ENCLOSURE 2 TO NL-10-045

2009 Offsite Dose Calculation Manual Changes and
Justification Package

ENTERGY NUCLEAR OPERATIONS, INC.
INDIAN POINT NUCLEAR GENERATING UNIT NOS. 1, 2, AND 3
DOCKET NOS. 50-03, 50-247, AND 50-286
LICENSE NO. DPR-5, DPR-26, AND DPR-64

OFFSITE DOSE CALCULATION MANUAL
(ODCM)

Figure D 4.1-1
MAP DEFINING UNRESTRICTED AREAS
FOR RADIOACTIVE GASEOUS AND LIQUID EFFLUENTS

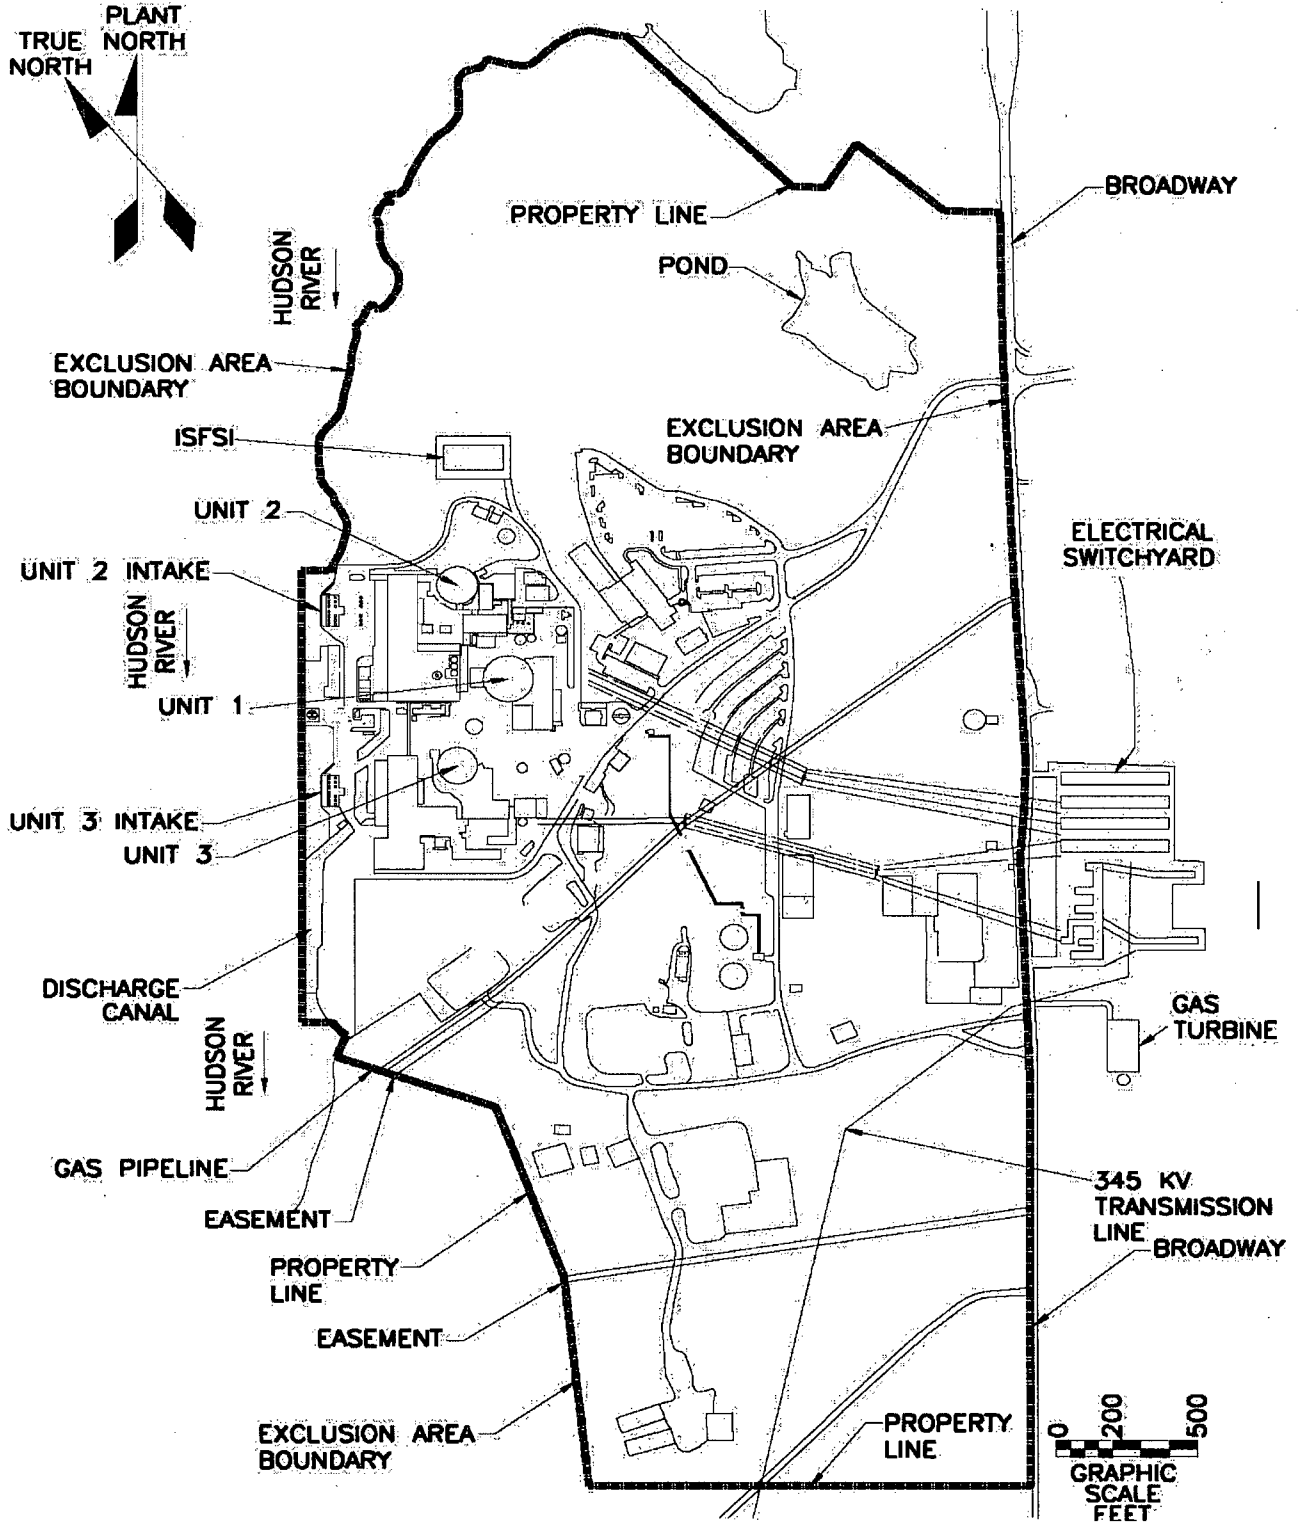
Added Lafarge well to REMP, Table 3.5.1-1, Section 3d, in place of using MW-40 and MW-51. Updated Figure D4.1-1 to remove depiction of these Monitoring Wells, which remain in RGWMP, but are removed from REMP.
